Access Compliance Report

Public Rights-of-Way

(Curb Ramps)

Intersection ID: N/A	Main Street: INDEPENDENCE_RD	Cross Street: CONFERENCE_DR	Location:	N
ADA ID: 577B4E108364	Ramp Type: PerpDiag	Initial Pass/Fail: Fail	Overall Compliance: No	Severity Score: 25

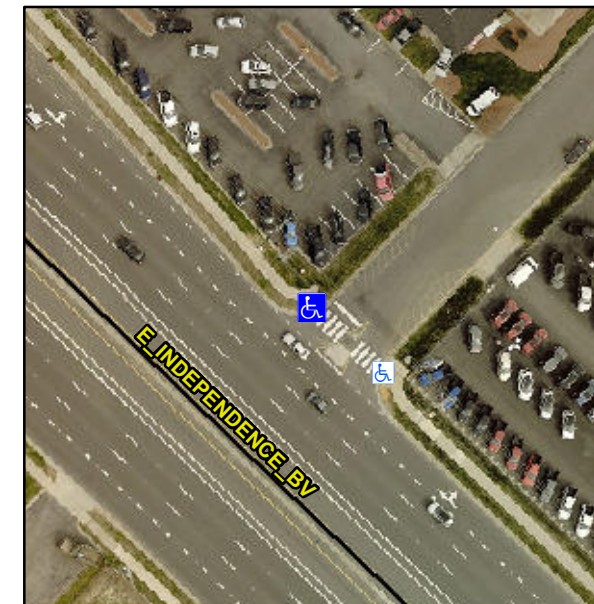
Not Found, R304.2.2, R304.5.3

Compliance	Description	Data	Compliance	Description	Data
N/A	Ramp Length (in)	74.0	No	Ramp Slope (%)	9.9
Yes	Ramp Width (in)	48.0	No	Ramp XSlope (%)	5.6
N/A	Flare Type LT	N/A	N/A	Flare Type RT	N/A
N/A	Flare Slope LT (%)	N/A	N/A	Flare Slope RT (%)	N/A
N/A	Flare Traversable LT?	N/A	N/A	Flare Traversable RT?	N/A
N/A	Landing Length (in)	N/A	N/A	DWS Provided?	N/A
N/A	Landing Width (in)	N/A	N/A	DWS Contrast?	N/A
N/A	Landing Slope (%)	N/A	N/A	DWS Length (in)	N/A
N/A	Landing X Slope (%)	N/A	N/A	DWS Full Width?	N/A
N/A	Landing Curb? (Y/N)	N/A	N/A	DWS Offset (in)	N/A
N/A	Shared Landing?	N/A			
N/A	Gutter Ponding?	N/A	N/A	Gutter Slope (%)	N/A
N/A	Gutter Lip Ht (in)	N/A	N/A	Gutter X Slope (%)	N/A
N/A	Painted X Walk1?	No	N/A	Painted X Walk2?	Yes
	X Walk 1 Direction	To SW		X Walk 2 Direction	To SE
N/A	X Walk 1 Width (in)	N/A	N/A	X Walk 2 Width (in)	122.0
	X Walk 1 Slope (%)	5.0		X Walk 2 Slope (%)	4.8
	X Walk 1 X Slope (%)	0.2		X Walk 2 X Slope (%)	4.9

Remove & Replace Curb Ramp With Two New Directional Ramps or Equivalent.
